Subject: MHI's Response to US-APWR DCD RAI No.779-5865 Revision 3 (SRP 09.04.03)

Response to Request for Additional Information
No. 779-5865, Revision 3

US-APWR Design Certification

RAI NO.:	**779-5865 REVISION 3**
SRP SECTION:	**09.04.03 – AUXILIARY AND RADWASTE AREA VENTILATION SYSTEM**
APPLICATION SECTION:	**DCD Section 9.4.3**
DATE OF RAI ISSUE:	**7/11/2011**

Figure 9.4.3-1 Auxiliary Building HVAC System Flow Diagram

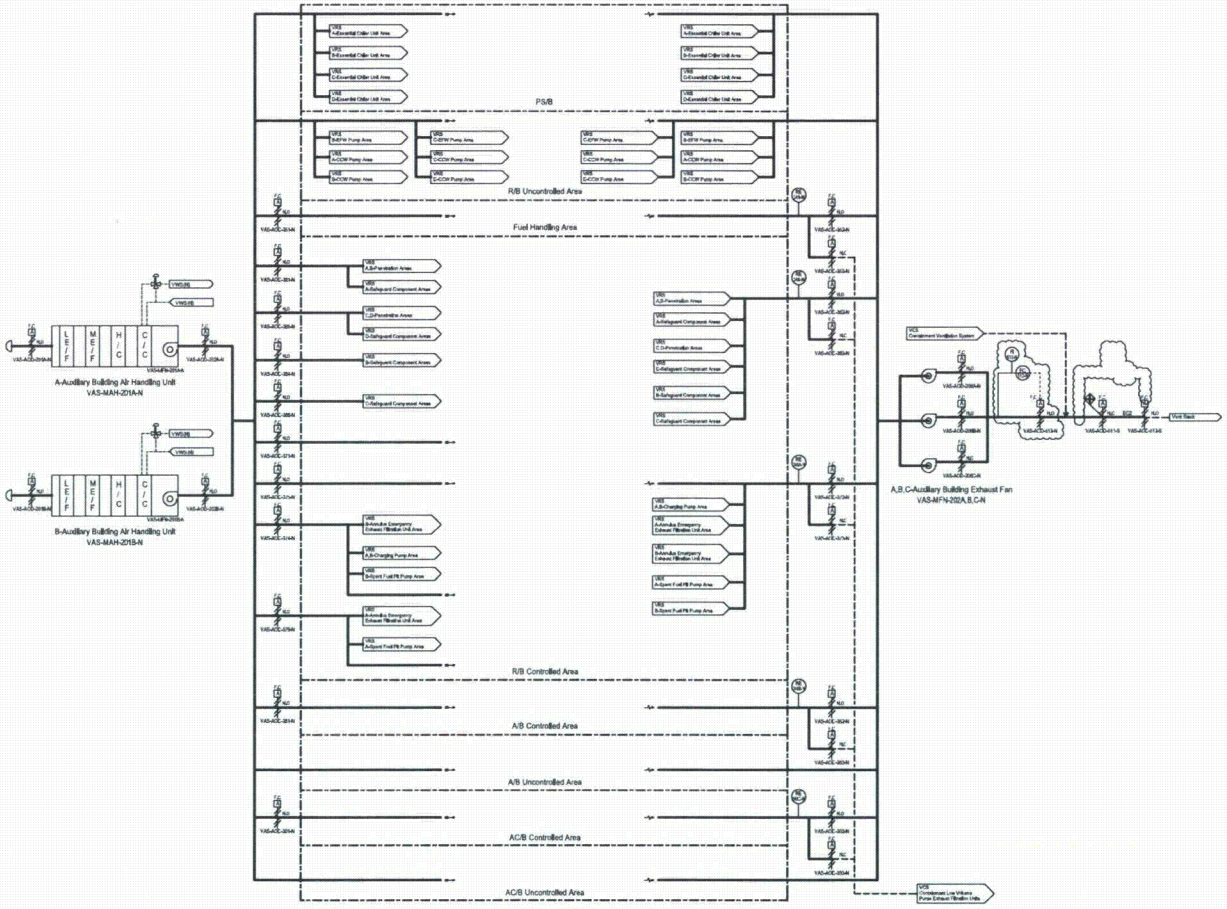
In Part 2 of question 09.04.03-13, the NRC requested that MHI verify that an unmonitored release will not occur under credible worst-case ventilation balance conditions for adjacent building HVAC systems. The concern was for all adjacent buildings including the containment. For example, there is a cross connection point from the containment low and high volume purge system just downstream of the auxiliary building exhaust fans (figure 9.4.3-1). The applicant should address whether it would be possible for the containment low or high volume purge systems to pressurize this VCS line cross connection point during containment purge starting at 2 psig containment pressure. Are the specified fan flow rates based

on 20 inches of water column developed across the fan or a combination of 2 psig plus the 20-inch water column of the fans? What would be the maximum flow rate under those conditions? Also, is the HVCP system flow rate at 30,000 cfm significantly above the margin between one auxiliary building air supply unit and one auxiliary building exhaust fan, could a resulting flow imbalance result in backflow? Does the applicant have adequate design controls in place to ensure the operating duct pressures at this cross connection will be properly balanced? What is the vent ducting pressure rating at this cross connection point? Why are there no backflow preventer dampers at this cross connection point? Is it possible for the flow dampers VAS-AOD-511-S and VAS-AOD-512-S to fail due to flow control transients induced in the control loop by the starting/running of the LVCP or HVCP? Could such conditions described above or the failures or operating overpressure conditions lead to backflow from the containment low or high volume purge system into the Auxiliary Building HVAC system or upset the Auxiliary Building from its slightly negative operating pressure relative to adjacent buildings and the ambient conditions?

In addition, the applicant's response to Part 2 of question 09.04.03-13 included the words "backdraft dampers installed at penetrations between controlled and clean areas prevent ventilation backflow from potentially contaminated areas." The staff notes that Figure 9.4.3-1 does not display these backdraft dampers and DCD Section 9.4.3 "Auxiliary Building Ventilation System" does not discuss the existence of the dampers. The staff requests that the applicant revise both DCD Section 9.4.3 and Figure 9.4.3-1 to include a discussion and representation of these backdraft dampers.

As shown in attachment-1, flow damper VAS-AOD-513-N will be installed to adjust the ABVS exhaust airflow rate to design flow rate described in DCD Subsection 9.4.3.2.1 regardless of the operation of HVCP and LVCP. HVCP does not operate under 2 psig containment pressure plus the pressure developed across the fan since HVCP operates during the refueling condition. During the operation of LVCP under the condition, the ABVS provides the design exhaust air by the adjustment of the flow damper VAS-AOD-513-N. Therefore, there is no airflow from HVCP and LVCP to ABVS under the condition.

As indicated in the response to Question No.9.4.3-15, DCD Subsection 9.4.3.2.1 will be revised to describe the backdraft dampers. This level of detail is not shown in the simplified flow diagram in DCD Figure 9.4.3-1.

DCD Figure 9.4.3-1 will be revised as shown in attachment-1.
